Agenda Item # 3

SUB-003865-2026

Mobile Terrace Subdivision, Resubdivision of Lots 1-5,
Block 2

- Subdivision approval to create three (3) legal lots of record from five (5) legal lots of record.

SITE PLAN

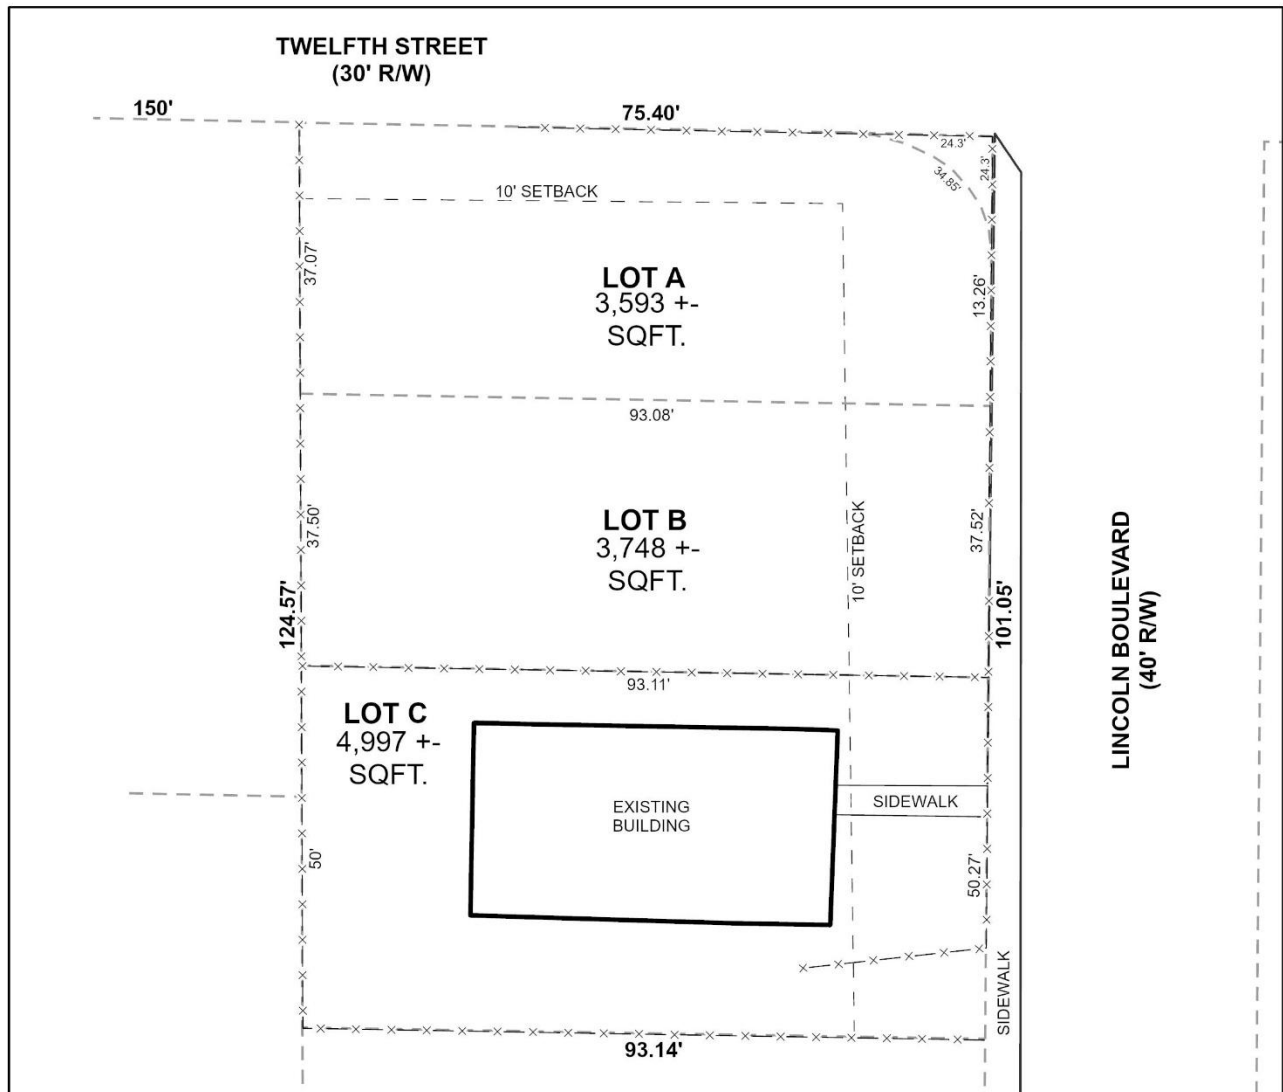
- A. Provide all of the required information on the SUBDIVISION PLAT (i.e. signature blocks, signatures, certification statements, written legal description, required notes, legend, scale, bearings and distances) that is required by the current Alabama State Board of Licensure for Professional Engineers and Land Surveyors.

- B. Revise NOTES # 15 to read - As shown on the 1984 aerial photo LOTS A, B, and C share the 1,800 sf of historical credit of existing (1984) impervious area towards stormwater detention requirement per Mobile City Code, Chapter 17, Storm Water Management and Flood Control) and share the 7,500 SF credit provided to the original SF residential lots as follows: LOT A – 3,100 sf, LOT B – 3,100 sf, and LOT C – 3,100 sf. Stormwater detention will be required for any additional impervious area that exceeds the allowable credit for that LOT.

- C. Retain NOTES 7, 8, 13, 14, and 16.
Email a pdf copy of the FINAL SUBDIVISION PLAT and LETTER OF DECISION to the Permitting Engineering Dept. for review at land.disturbance@cityofmobile.gov prior to obtaining any signatures. No signatures are required on the drawing.

Proposed Lot A has frontage along Twelfth Street and Lincoln Boulevard, while proposed Lots B and C have frontage along Lincoln Boulevard. Both streets are minor streets with asphalt wing gutters and are required to have 50-foot-wide rights-of-way pursuant to Section 6.B.9. of the Subdivision Regulations. The preliminary plat depicts a substandard 30-foot-wide right-of-way along Twelfth Street and a 40-foot-wide right-of-way along Lincoln Boulevard. Previous subdivision approvals in the area required dedication sufficient to provide 30 feet from the centerline of each street. However, the existing rights-of-way are substandard, and the 60-foot right-of-way requirement applies to streets with open-ditch drainage. Two (2) nearby subdivision approvals along Thirteenth Street, in 2012 and 2013, required only 50-foot-wide rights-of-way.

Lot A is a corner lot at the intersection of Twelfth Street and Lincoln Boulevard and is therefore subject to the 25-foot radius requirement of Section 6.C.6. of the Subdivision Regulations. Sufficient dedication is depicted on the preliminary plat, and this information should be retained on the Final Plat, if approved.

The proposed lots do not meet the minimum area and width requirements of Sections 6.C.2.(a)(1) and 6.C.2.(b)(2) of the Subdivision Regulations for lots served by public water and sanitary sewer in an R-1, Single-Family Residential Suburban District. Similar lot configurations are common within the surrounding neighborhood, which was originally platted with 25-foot-wide by 100-foot-deep lots. Therefore, a waiver of Sections 6.C.2.(a)(1) and 6.C.2.(b)(2) may be appropriate.

The proposed lots are labeled with their areas in both square feet and acres on the preliminary plat. This information should be retained on the Final Plat, if approved, adjusted for any required right-of-way dedication.

A 25-foot front yard setback is illustrated along Lincoln Boulevard on the preliminary plat, as required by Section 6.C.8. of the Subdivision Regulations and Article 2, Section 64-2-5.E. of the Unified Development Code (UDC) for lots in an R-1, Single-Family Residential Suburban District. This setback should be retained on the Final Plat, if approved, adjusted for any required dedication.

Lot A also depicts a 10-foot front yard setback along Twelfth Street, consistent with the setback variance approved by the Board of Adjustment in 2025, which subsequently expired. A subsequent Board of Adjustment application has been submitted and is scheduled for consideration at the September 14, 2026, meeting. Therefore, the plat should be revised to depict a 25-foot front yard setback along Twelfth Street, if approved, adjusted for any required dedication, unless the associated setback variance is approved by the Board of Zoning Adjustment.

1. Revision of the plat to illustrate dedication sufficient to provide 25 feet from the centerline of Twelfth Street and Lincoln Boulevard;
2. Retention of the 25-foot corner radius at the intersection of Twelfth Street and Lincoln Boulevard, in accordance with Section 6.C.6. of the Subdivision Regulations, or as approved by the City Engineer and Traffic Engineering Director;
3. Retention of the lot areas, in both square feet and acres, on the Final Plat, adjusted for any required right-of-way dedication;
4. Retention of the 25-foot front yard setback along Lincoln Boulevard on the Final Plat, adjusted for any required right-of-way dedication;

5. Revision of the plat to illustrate a 25-foot front yard setback along Twelfth Street, adjusted for any required right-of-way dedication, unless a Setback Variance is approved by the Board of Zoning Adjustment;
6. Compliance with all Engineering comments noted in this staff report;
7. Placement of a note on the Final Plat stating all Traffic Engineering comments noted in this staff report;
8. Compliance with all Urban Forestry comments noted in this staff report;
9. Compliance with all Fire Department comments noted in this staff report; and
10. Full compliance with all other applicable codes and ordinances.
